Design Review Commission Report

Meeting Date: Thursday, August 2, 2012
(Continued from the July 9, 2012 DRC meeting.)

Subject: **210 North Oakhurst (PL# 120 9649)**
A request for an R-1 Design Review Permit to allow the construction of a new two-story single-family residence located in the Central Area of the City south of Santa Monica Boulevard.

PLANTING PLAN

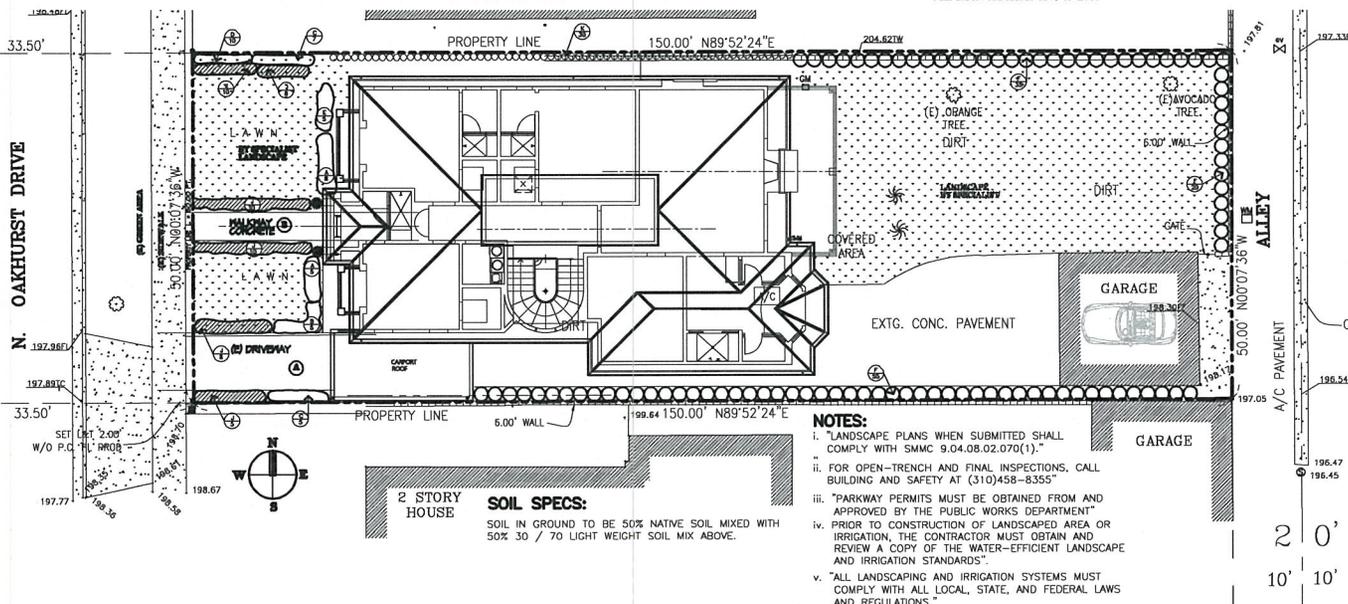
- The porte cochere doesn't blend well with the house design.
- The landscape plan needs to be more fully developed and more lush.
- The roof finish with the rafter tails and the moldings doesn't blend to make a clean look.

- The privacy of the neighbors should be considered – landscaping along the side property lines may help to mitigate privacy concerns.

- 1.0 More shrubs & plants was provided on both sides to have more privacy between neighbors and the property.
-
-

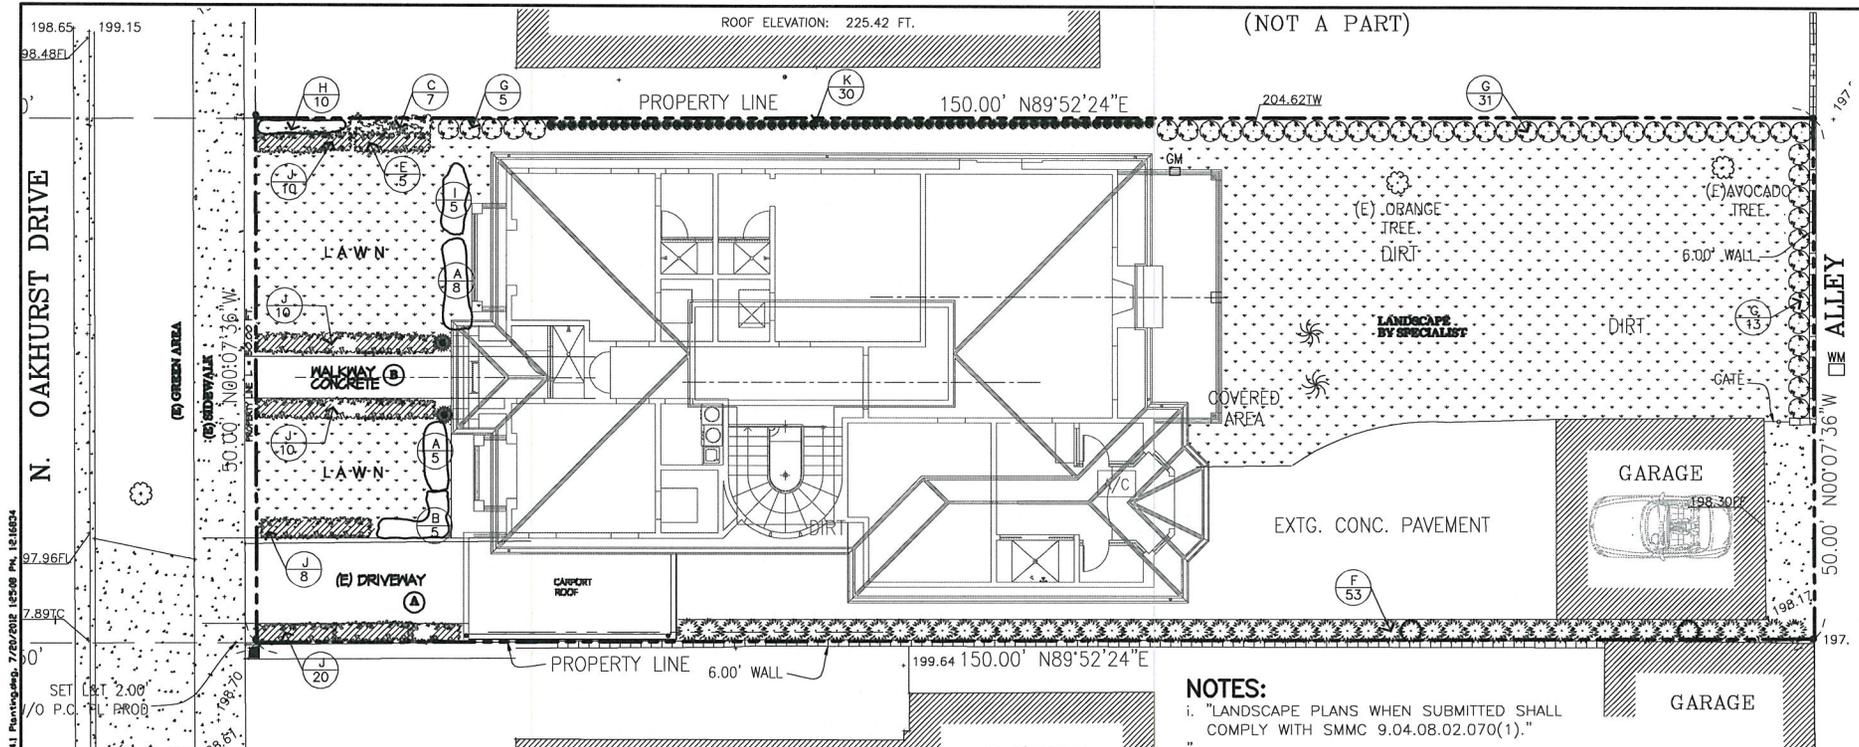
- The two story entry with the columns on each side doesn't fit the scale of house and a single-story entry would be more appropriate.
- The balcony banding is too thick.

- 1.0 Column pilaster & big corbel was removed provided by a new arch entry.
- 2.0 Quions was provided on both edge corner of the bldg. adding as italianate design element
- 3.0 A small contineous pre-cast molding below the roof eave corbels is added as one of the component of italianate house.
- 4.0 Oversized moldings are being modefied not to overimposed design characteristics.
- 5.0 Sloped wall at carport area is modefied into a straight wall parapet.
- 6.0 A louver side panels was created on second floor balcony to match the first floor .
